**SUBJECT:** Hilton West Windsor Property  
Concept Plan and Zoning Amendment Review  
Comment Review Memo #1  
PB 19-16  
Old Trenton Road and Southwest Corner of Dorchester Drive  
Block 37; Lots 6 and 7  
West Windsor Township, Mercer County, New Jersey

**SUBJECT:** Hilton West Windsor Property (PB 19-16)  
 Concept Plan and Zoning Amendment  
 Block 37, Lots 6 & 7  
 VCEA Project No. 19-31-WW

Subject: Hilton West Windsor Property  
Concept Plan and Zoning Amendment  
Block 37 Lots 6 and 7

SUBJECT: **Hilton West Windsor  
Concept Plan & Zoning Amendment**  
Block 37, Lots 6 and 7  
#2001 Old Trenton Road @ Dorchester Drive  
PB 19-16

Map 1: Aerial of Subject Site (scale: 1" = 500')

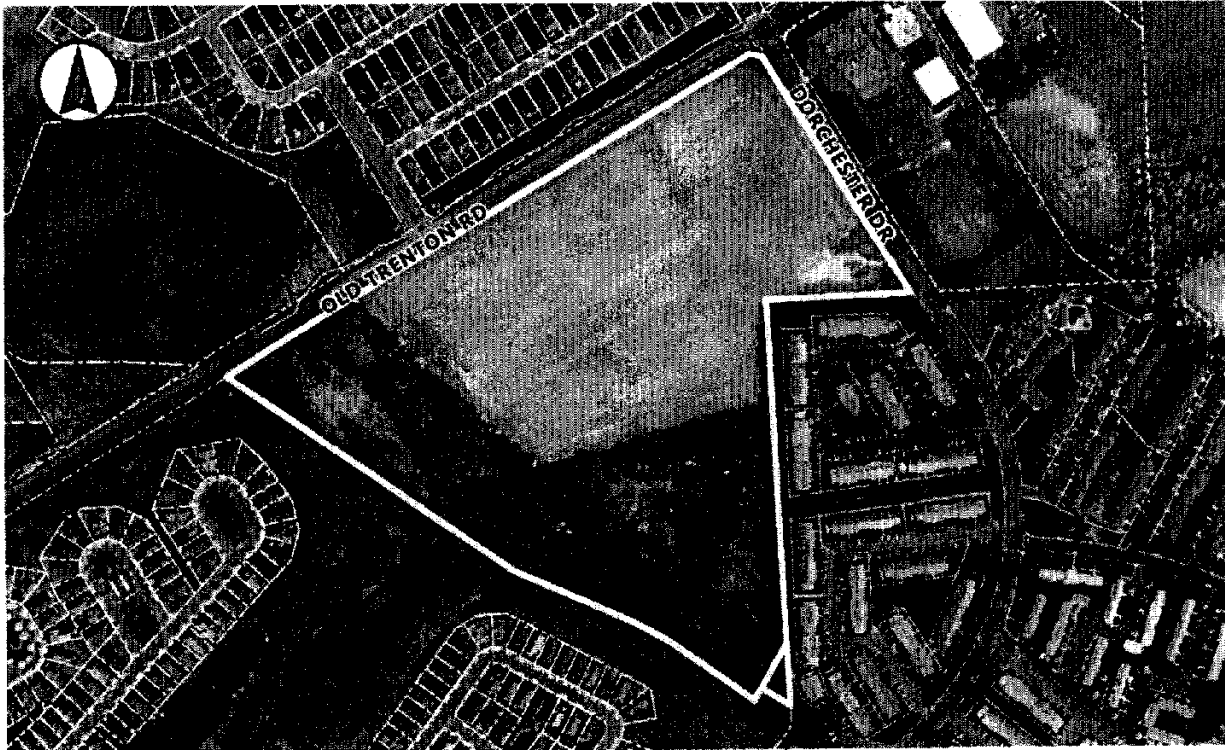
5. Stormwater Basin. Section 200-91.P.(4)(a)[2][a] encourages basin areas to be graded creatively to blend into the surrounding landscape and imitate a natural depression with an irregular edge. The applicant and the Board should discuss how this proposed berm design addresses this design criteria. We defer to the Township Landscape Architect regarding this matter.
